Technical Bulletin 086

Title: GDHA gas cooker product range modification

Date issued: 20 September 2010

GDHA Installation/modification Instructions

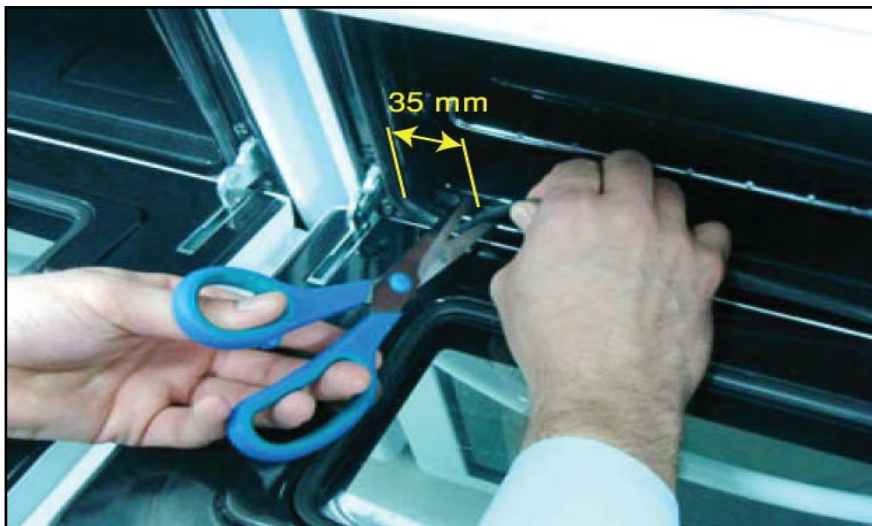
Gas Safe Register has been advised of an important safety modification to the grill compartment on a number of gas cookers that are marketed by GDHA.

The appliance manufacturer's instructions for these appliances **require that the grill door should be open at all times whilst the grill is in operation**. However, if the door is **closed** by the gas user, the grill combustion process can be affected due to vitiated air, causing higher than expected levels of carbon monoxide (CO) to be produced.

To ensure that there is an adequate supply of combustion air to the grill burner in the event that the grill door is inadvertently closed during the grilling process, a modification that involves removing the bottom section of the cavity door seal has been developed.

It is important that during installation of this product that you carry out the following modification to the Grill door seal **prior** to installation.

Open the Grill Door

Pull the bottom of the seal away from the cooker without removing the hooks from the hole and cut the seal 35mm in from the hook on both the bottom left hand and right hand corners of the seal as shown in the picture below and remove the bottom piece of the seal.

Close the Grill Door
